ENERGY UPGRADES
MILFORD COURTHOUSE
MILFORD, CONNECTICUT
PROJECT: BI- 2B - 315

BID OPENING	**1:00 P.M.**	**MARCH 31, 2010**
ADDENDUM NUMBER 4	**DATE OF ADDENDUM**	**MARCH, 25, 2010**

BID OPENING	**1:00 P.M.**	**MARCH 31/2010**
ADDENDUM NUMBER 2	**DATE OF ADDENDUM**	**MARCH, 18, 2010**

BID OPENING	**1:00 P.M.**	**MARCH 31, 2010**
ADDENDUM NUMBER 1	**DATE OF ADDENDUM**	**MARCH, 18, 2010**

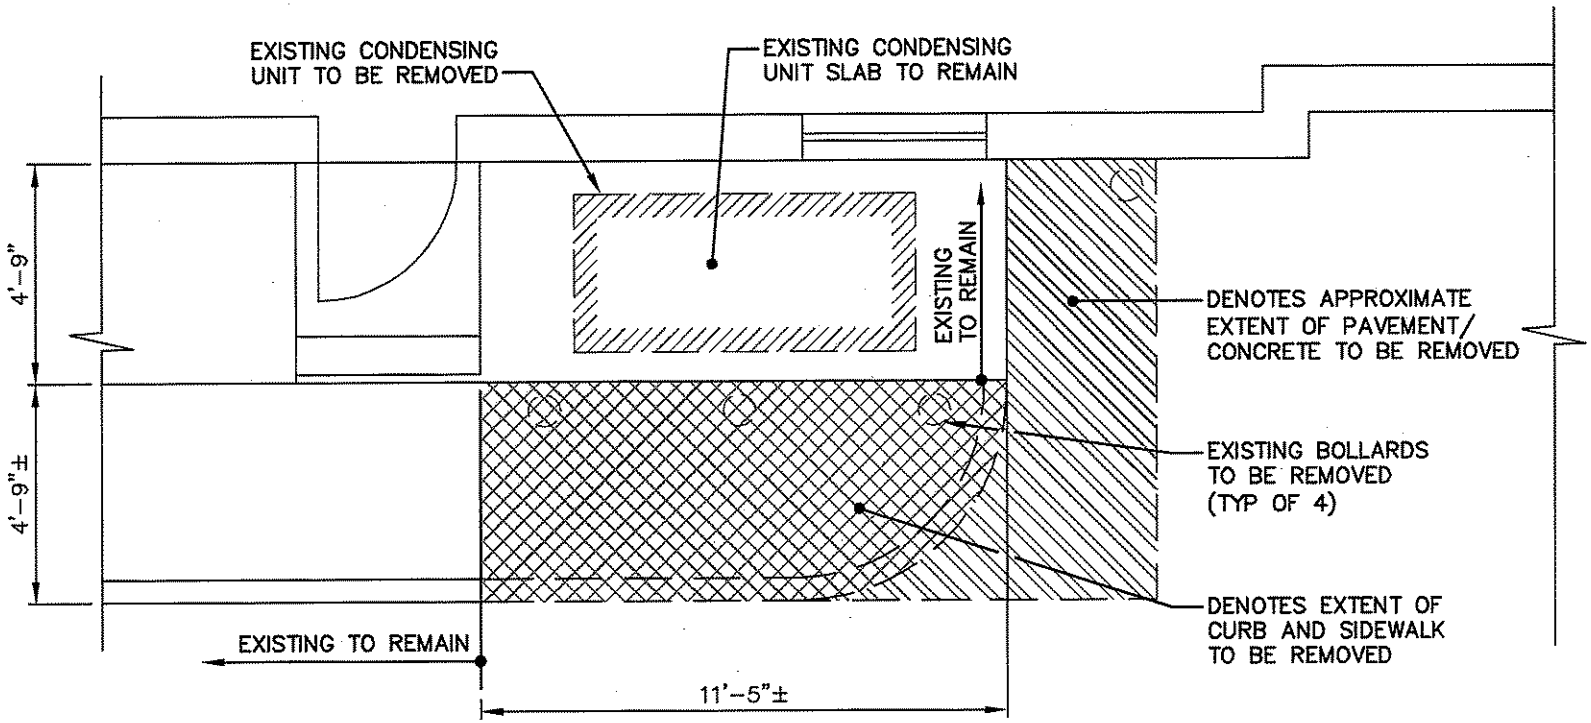
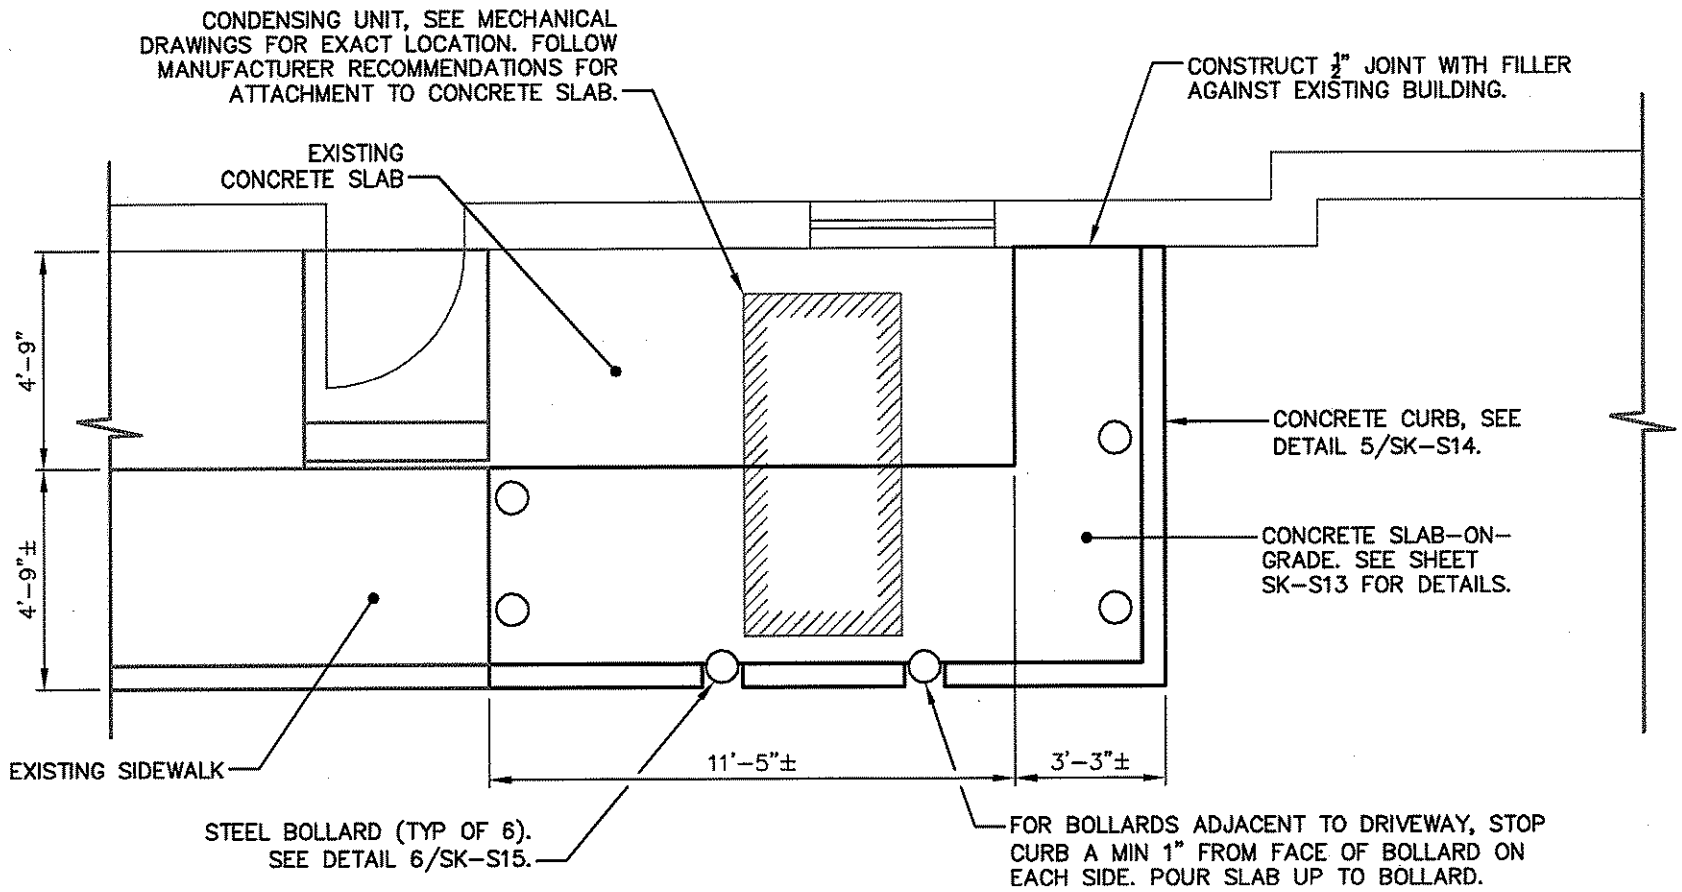
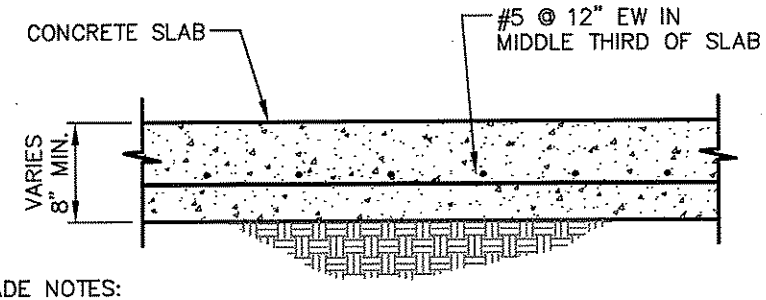
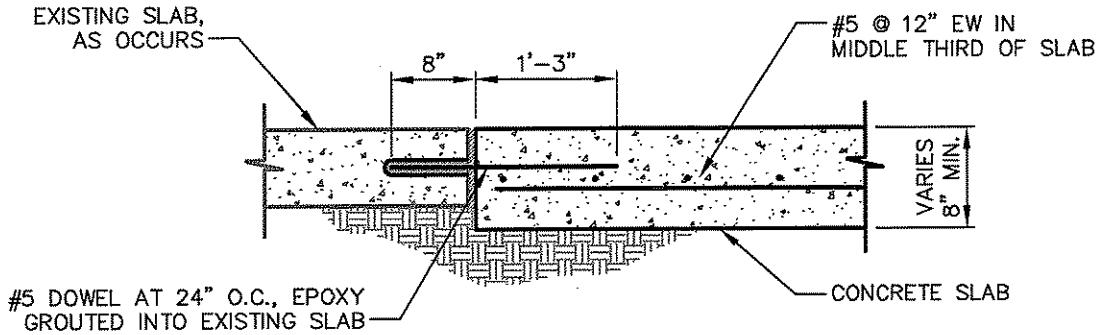
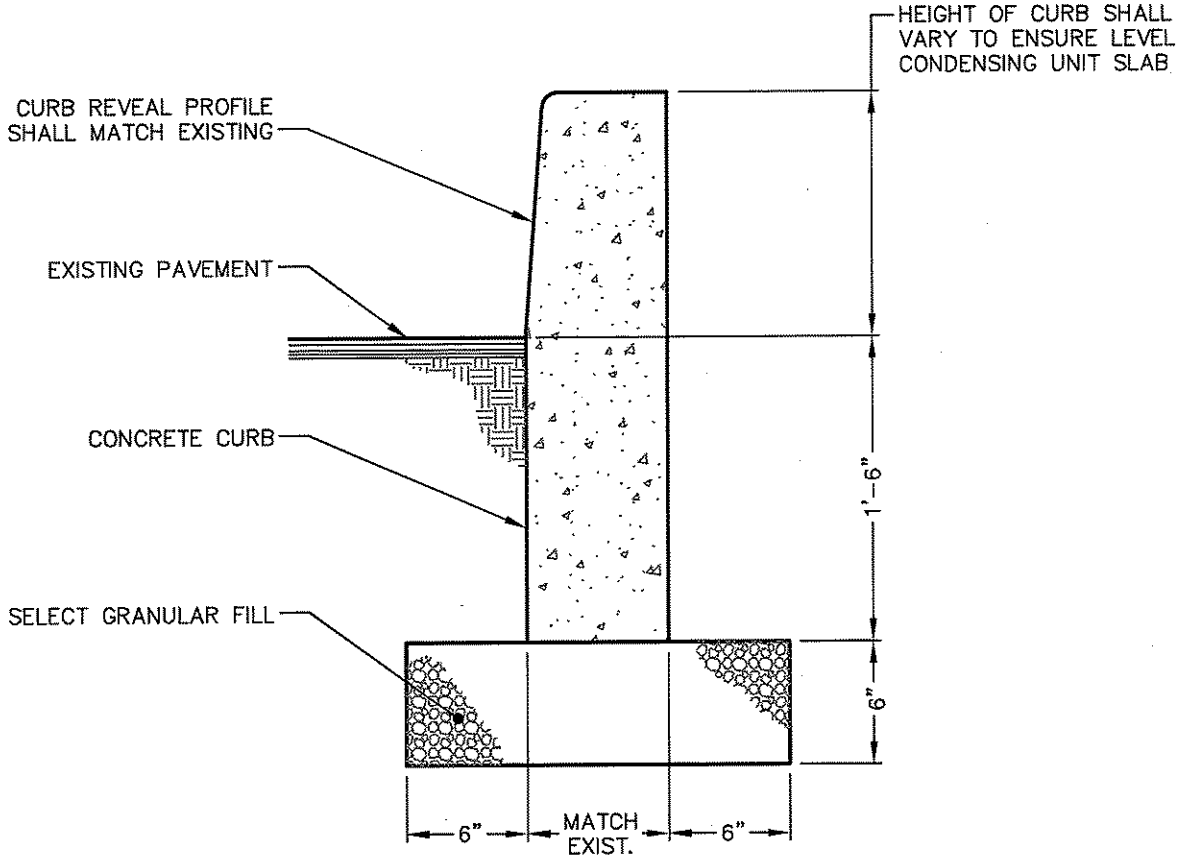
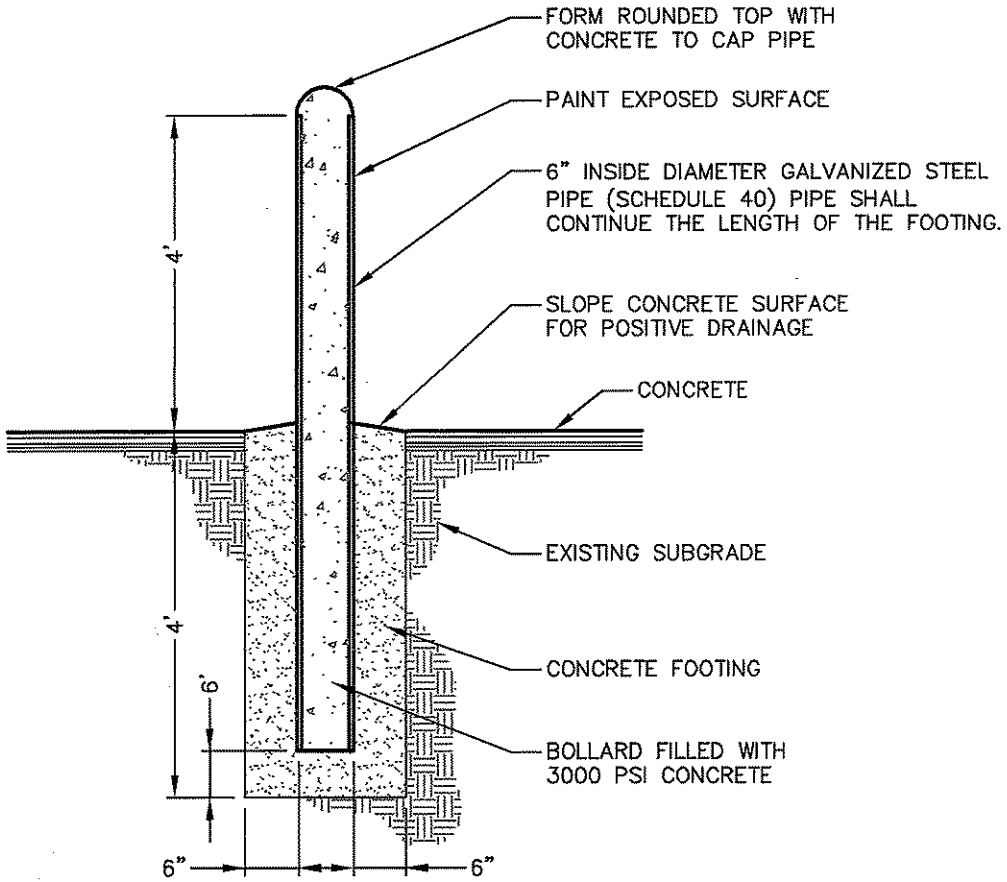
Add scope of work to drawing M-1.1 indicated by attached sketches SK-S10 thru SK-S15.

PROJ. No.: 20050024.B11
DATE: FEBUARY 11, 2010
SKME1.0

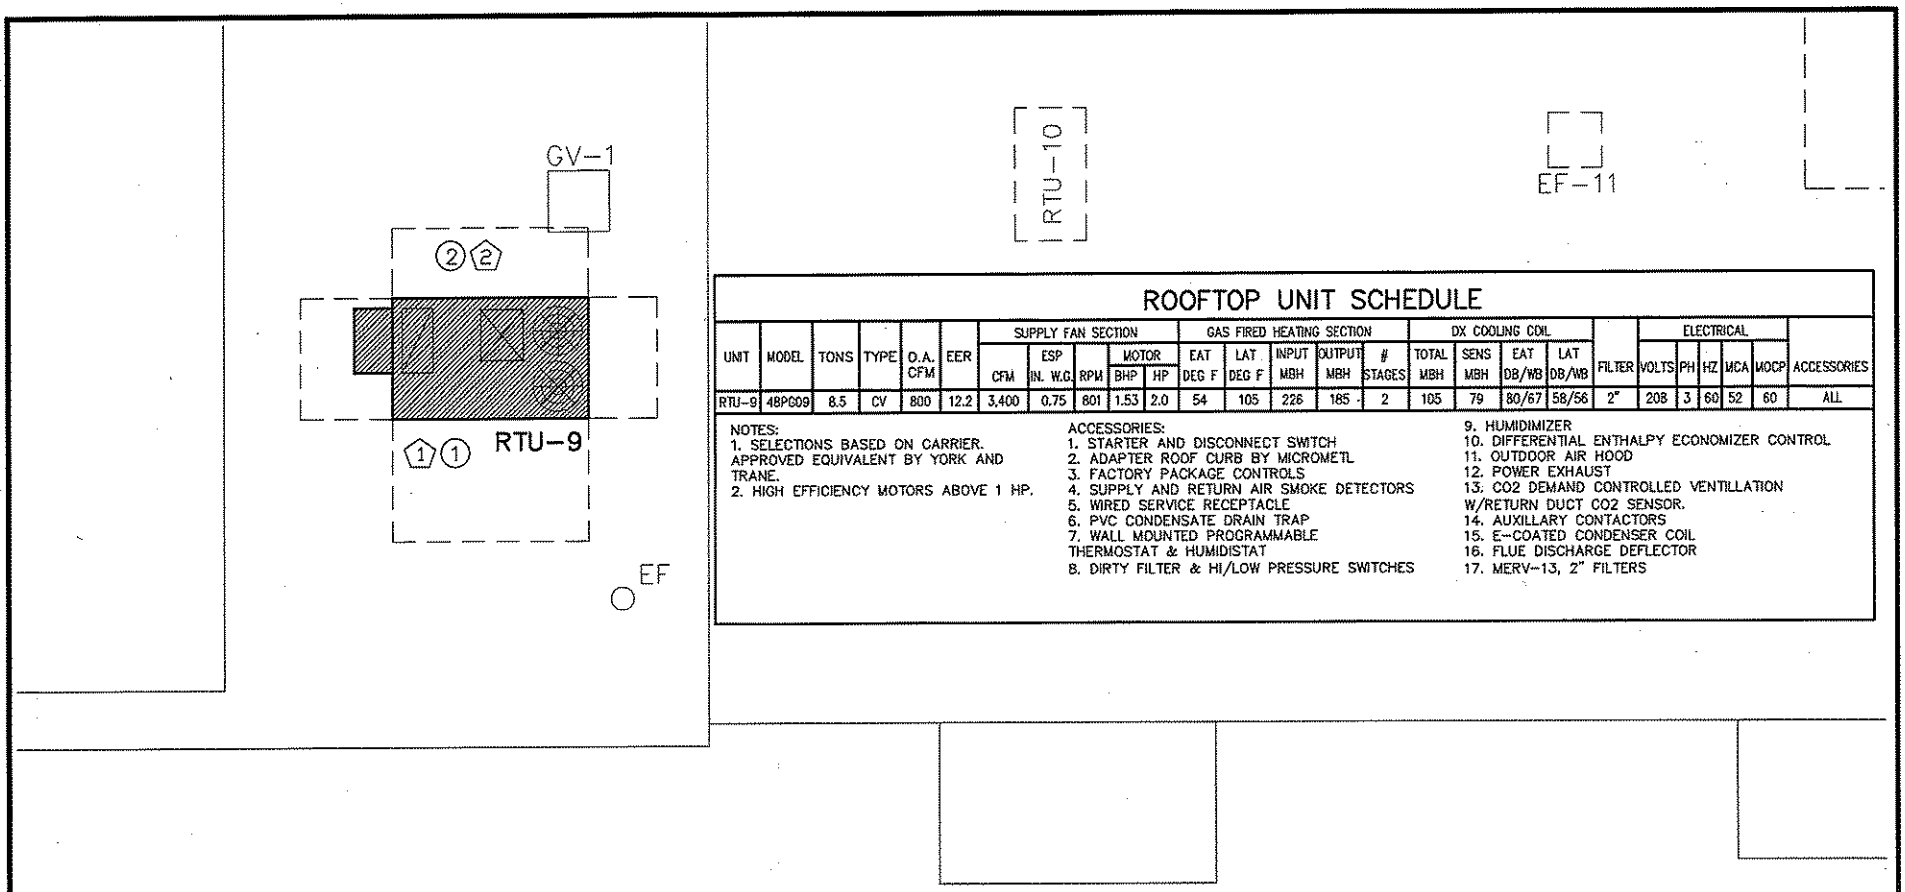
Add Alternate #1, RTU-9 replacement to scope of work on drawing M-1. Additional scope of work for Alternate #1 is indicated on attached sketch SKME-1.0. Break out price of work for RTU-9 replacement, and provide a separate cost for the Alternate #1.
